Question 1 : about max temperature

Question 2 : boards condition of SOA

Question 3 : SOA for our customer condition

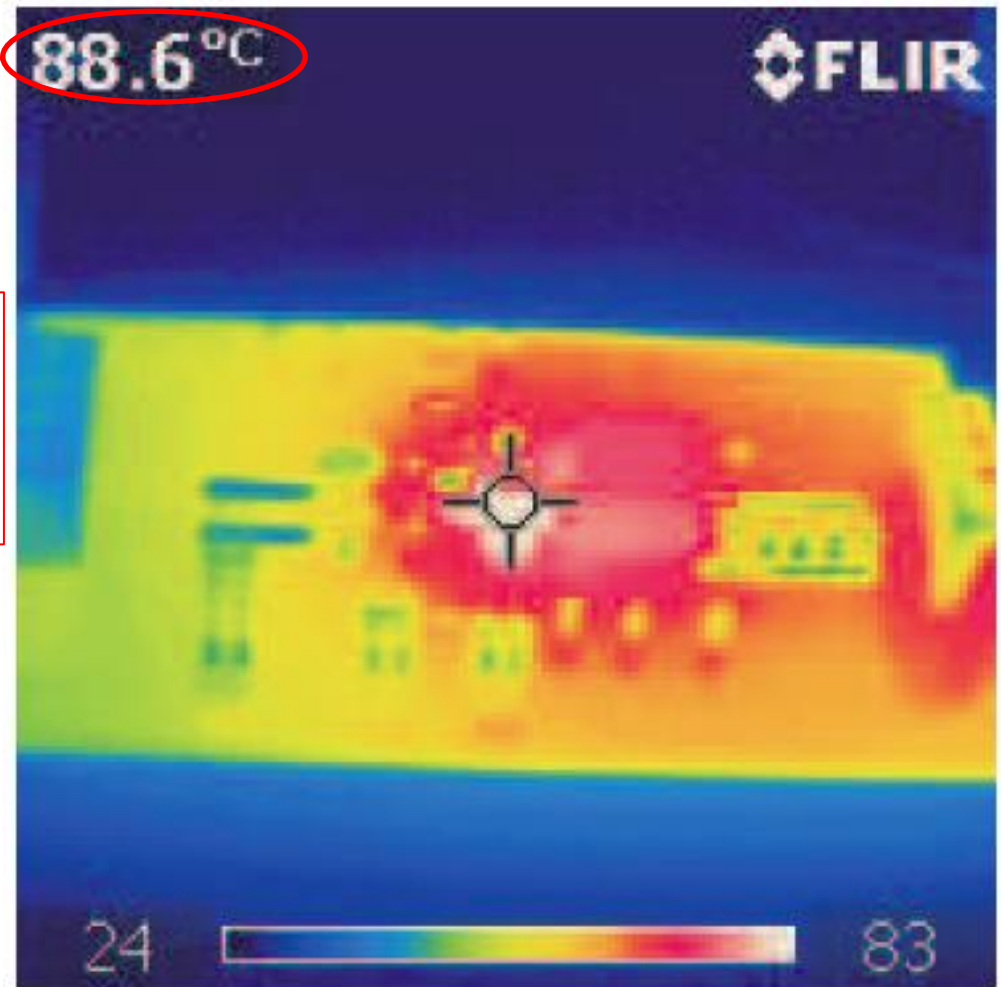
I think that this temperature is maximum temperature of this image. Is this temperature case temperature of TPS53355?

Figure 34. Safe Operating Area

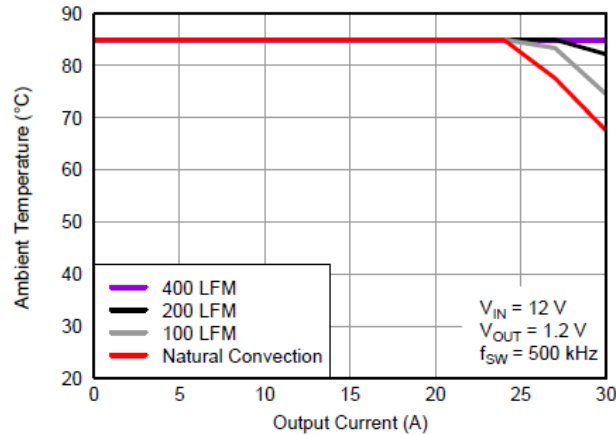
Above figures are Safe operating area from TPS53355 datasheet P.14.
Could you please let me know the layer structure of this data?
Is this same boards with EVM ?
